# Access Compliance Report

## Public Rights-of-Way

Intersection ID: 13994	Main Street: E_3RD_ST	Cross Street: S_TORRENCE_ST	Location: NE
ADA ID: 4E5B8278DF38	Ramp Type: Perp	Initial Pass/Fail: Fail	Overall Compliance: No
Severity Score: 33.75			
Codes/Mitigation Info/Possible Solution		Field Measurements/Component Compliance

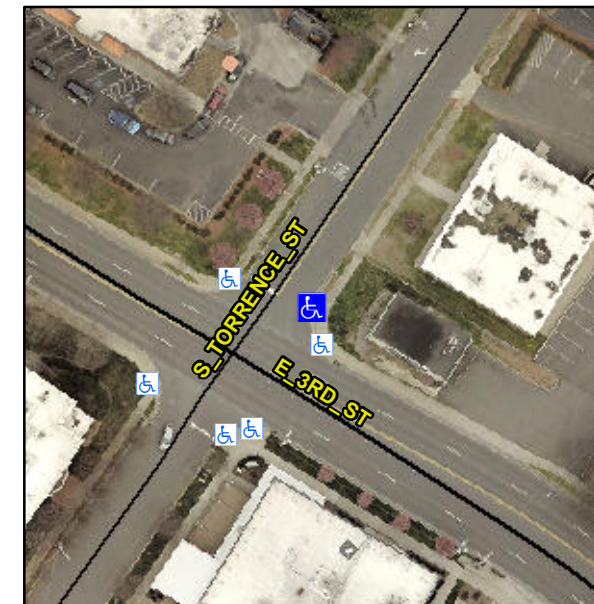
**Not Found, R304.5.1, R304.5.3**

Compliance	Description	Data	Compliance	Description	Data
N/A	Ramp Length (in)	81.0	Yes	Ramp Slope (%)	5.3
No	Ramp Width (in)	36.0	No	Ramp XSlope (%)	14.0
N/A	Flare Type LT	N/A	N/A	Flare Type RT	N/A
N/A	Flare Slope LT (%)	N/A	N/A	Flare Slope RT (%)	N/A
N/A	Flare Traversable LT?	N/A	N/A	Flare Traversable RT?	N/A
N/A	Landing Length (in)	N/A	N/A	DWS Provided?	N/A
N/A	Landing Width (in)	N/A	N/A	DWS Contrast?	N/A
N/A	Landing Slope (%)	N/A	N/A	DWS Length (in)	N/A
N/A	Landing X Slope (%)	N/A	N/A	DWS Full Width?	N/A
N/A	Landing Curb? (Y/N)	N/A	N/A	DWS Offset (in)	N/A
N/A	Shared Landing?	N/A			
N/A	Gutter Ponding?	N/A	N/A	Gutter Slope (%)	N/A
N/A	Gutter Lip Ht (in)	N/A	N/A	Gutter X Slope (%)	N/A
N/A	Painted X Walk1?	No	N/A	Painted X Walk2?	N/A
	X Walk 1 Direction	To NW		X Walk 2 Direction	N/A
N/A	X Walk 1 Width (in)	N/A	N/A	X Walk 2 Width (in)	N/A
	X Walk 1 Slope (%)	1.4		X Walk 2 Slope (%)	N/A
	X Walk 1 X Slope (%)	10.9		X Walk 2 X Slope (%)	N/A

**Remove & Replace Entire Ramp.**
